December 10, 2019
Medway Planning & Economic Development Board
Meeting

Choate Trail Way Definitive Subdivision
Plan Public Hearing

- Public Hearing Notice dated 11-21-19
- Abutter Notice dated 11-22-19
- Subdivision Application
- Development Impact Report
- Definitive Subdivision Plan dated 11-8-19 by Connorstone Engineering
- Historical Commission Demolition Approval dated 5-2-19
- SAC memo dated 12-3-19 to Town staff requesting review and comments
- PGC plan review comments dated 12-4-19

DEFINITIVE SUBDIVISION PLAN
EROSION CONTROL PLAN
CHOATE TRAIL WAY
IN
MEDWAY, MASS.

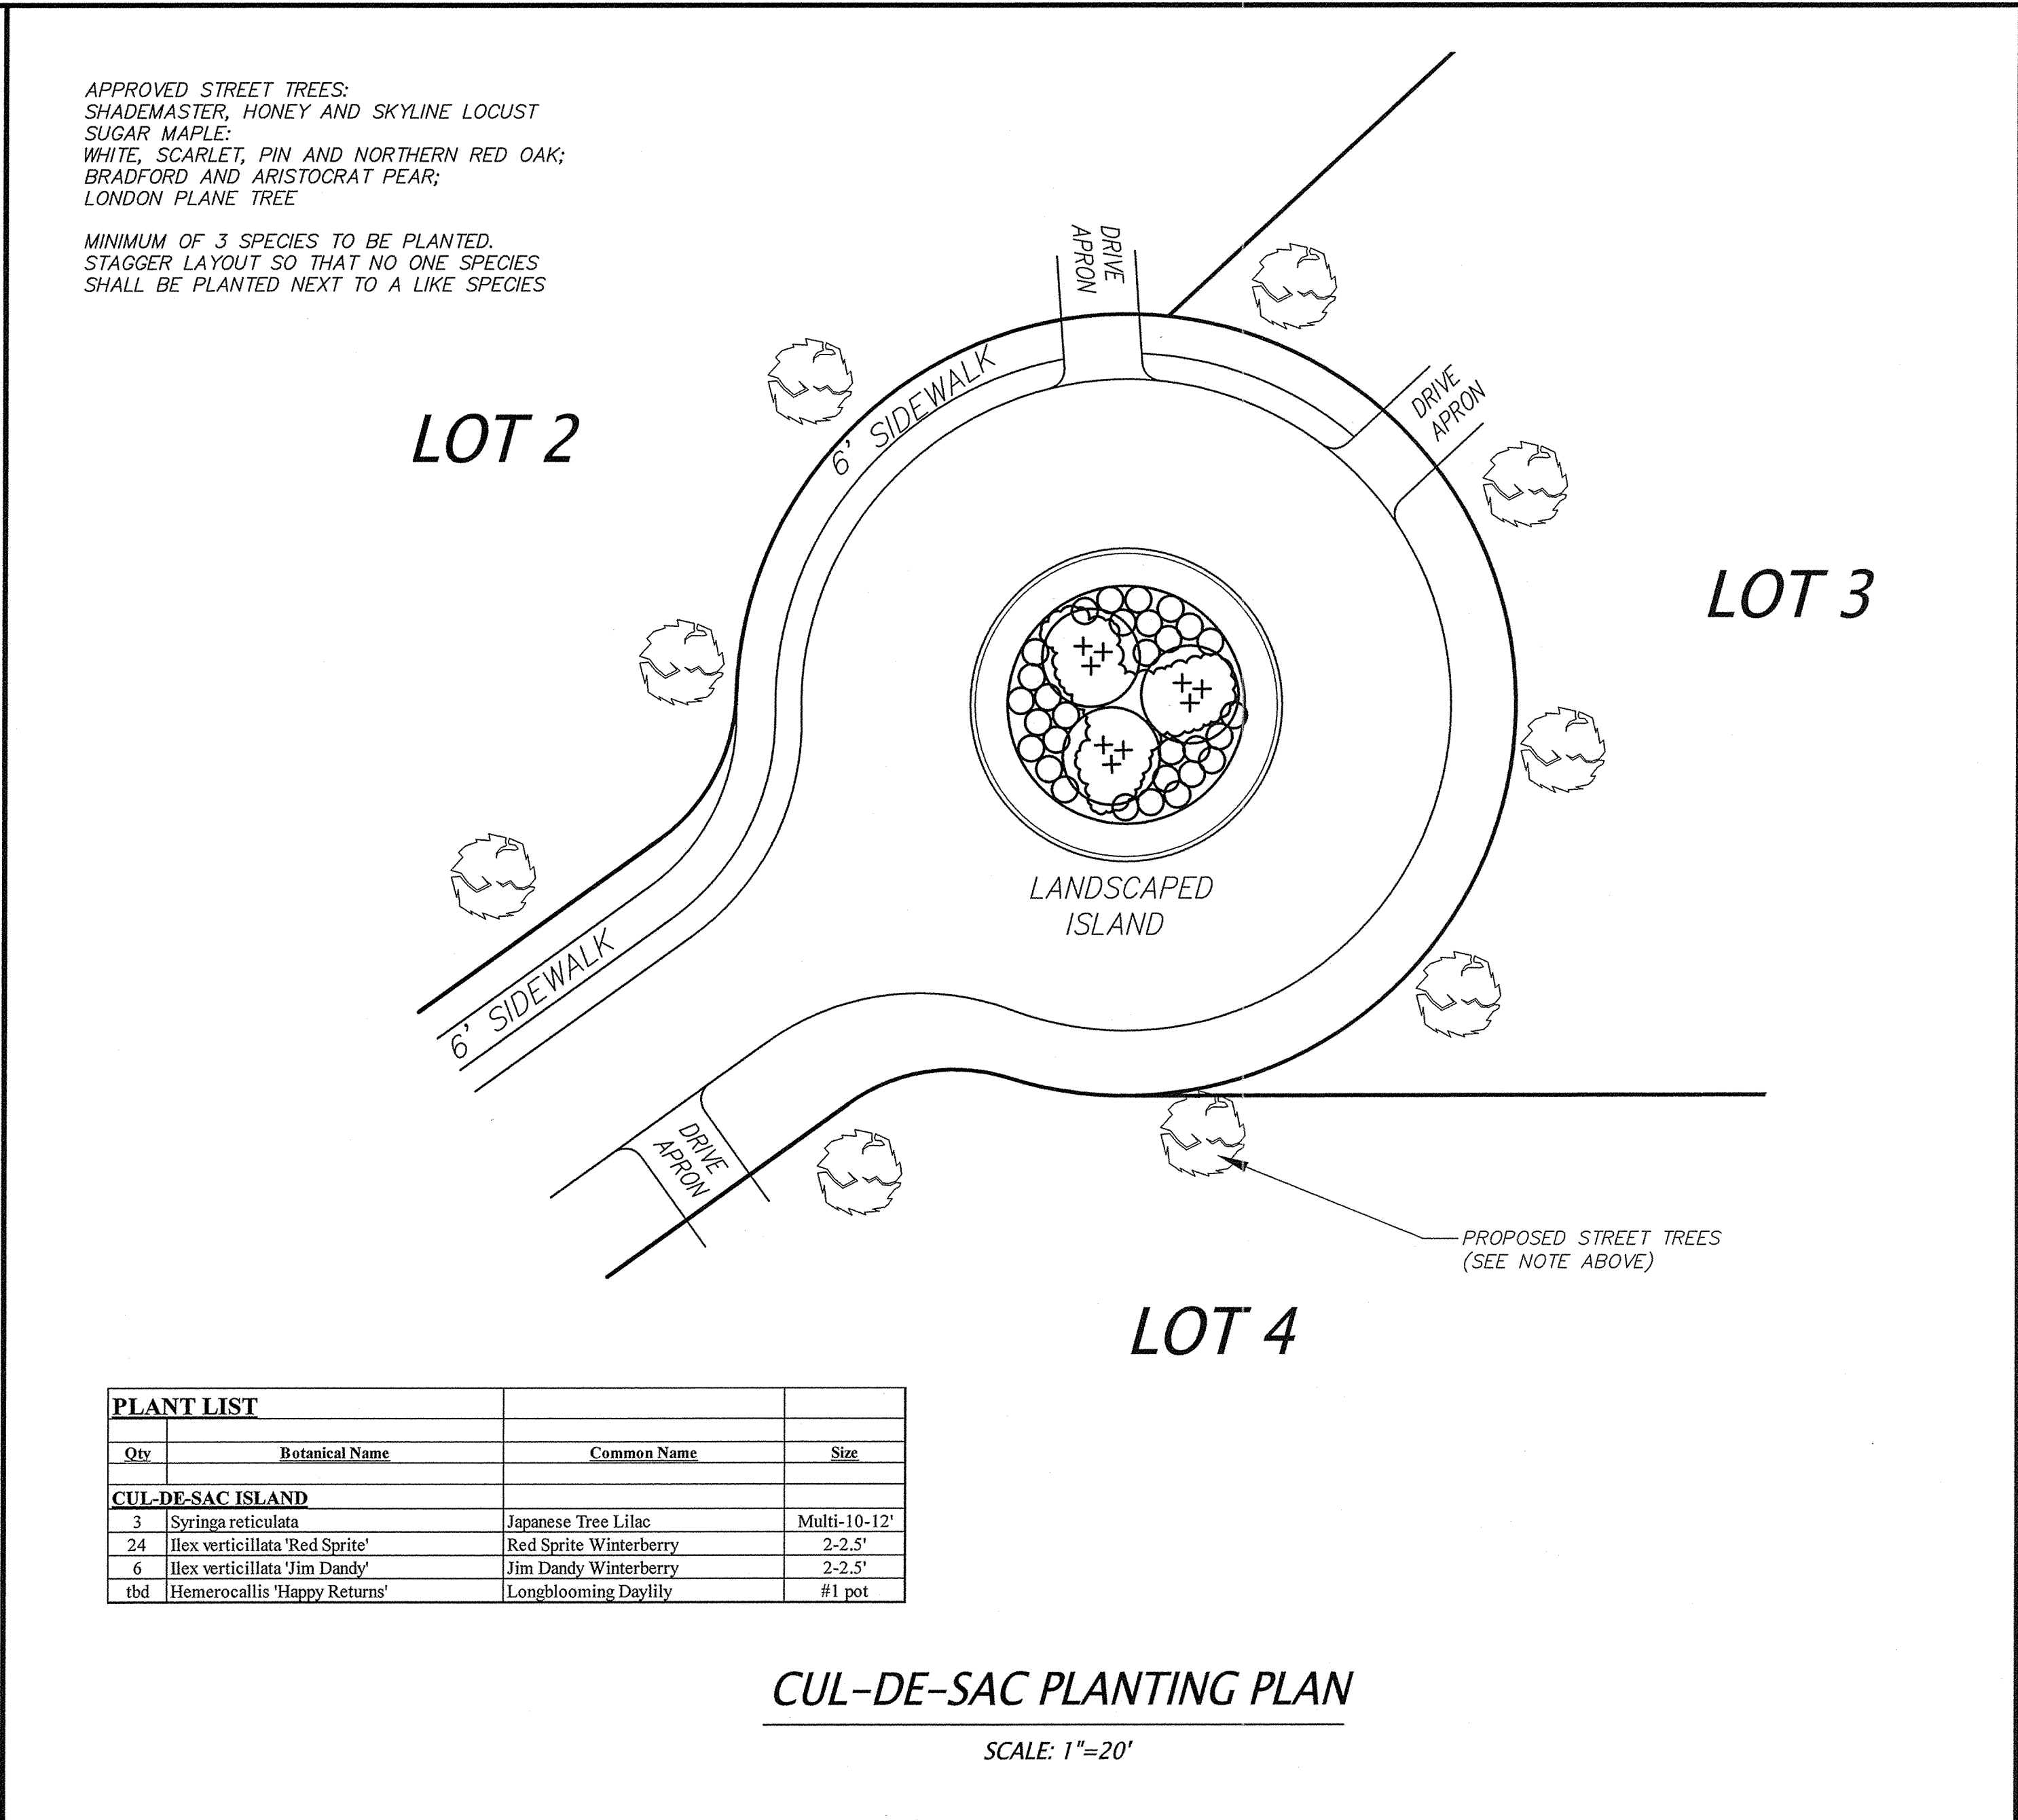
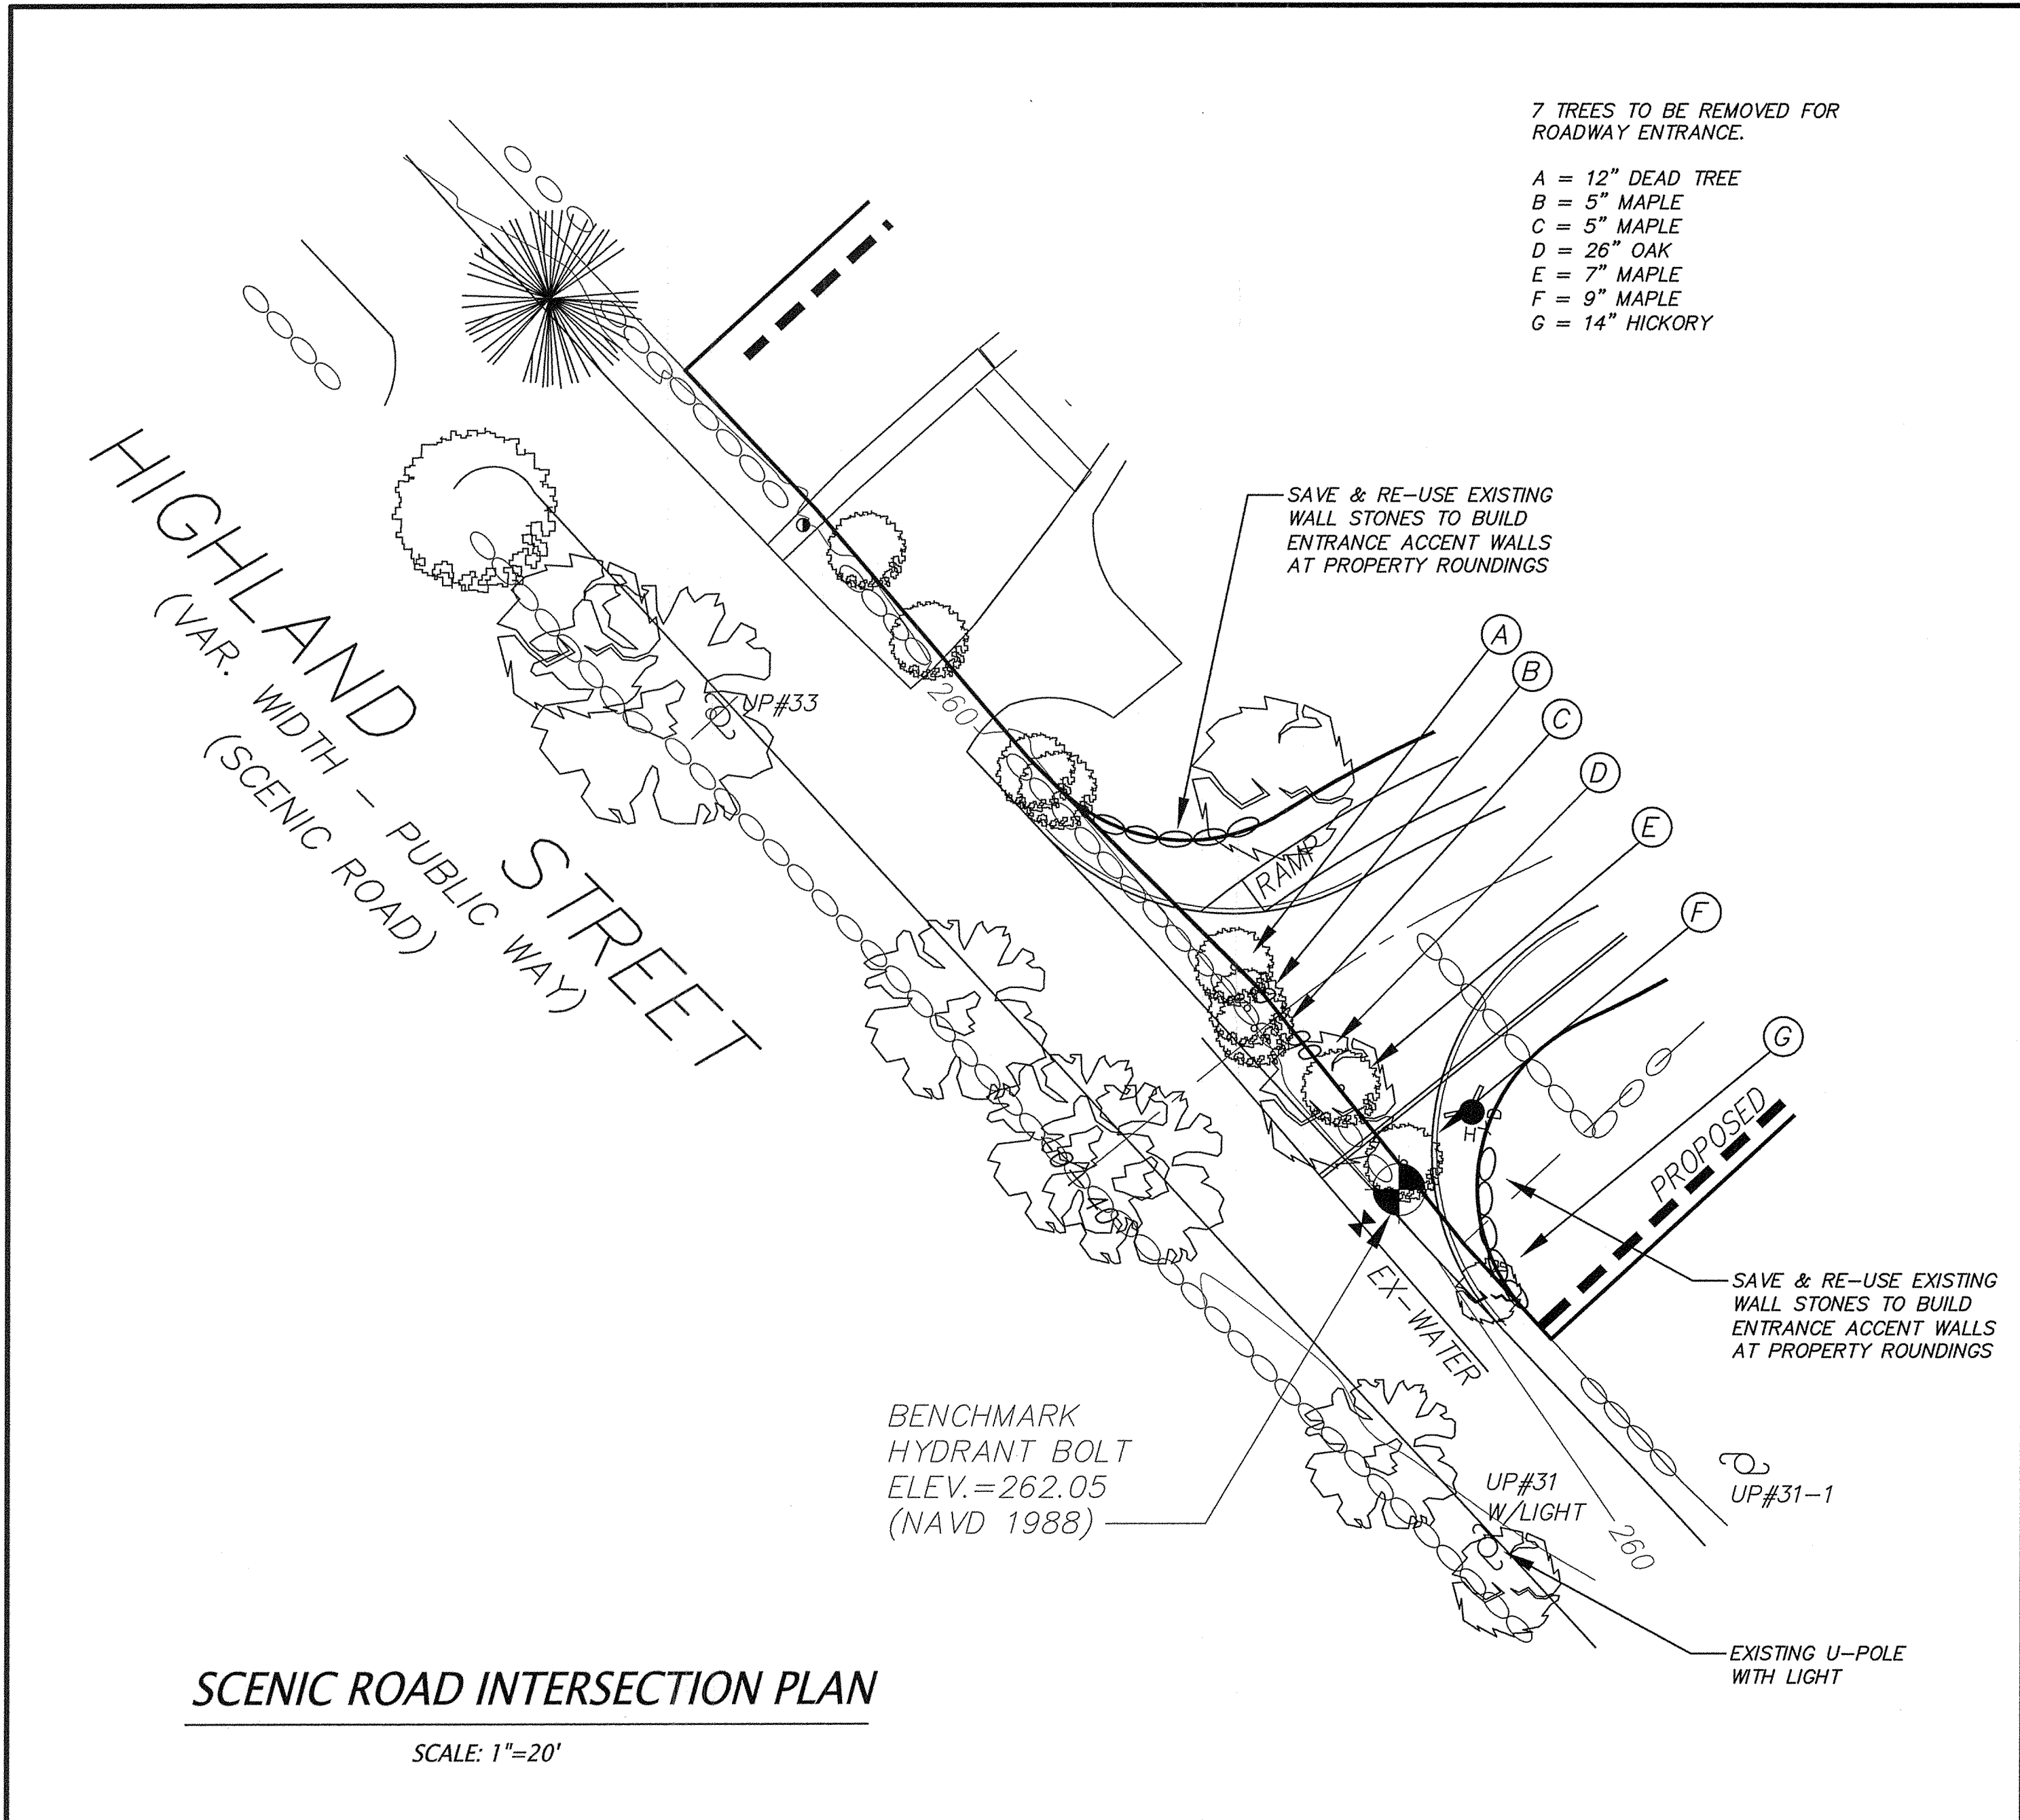
23. The Applicant shall coordinate with the Medway Public Safety Officer to determine if a painted "STOP" and stop line are required to be proposed.
24. Sheet 4 of the Plans shows 4 dashed polygons within the proposed roadway that do not have any description. If the polygons are proposed inlet protection, please relocate to show the polygons over the proposed catch basins.
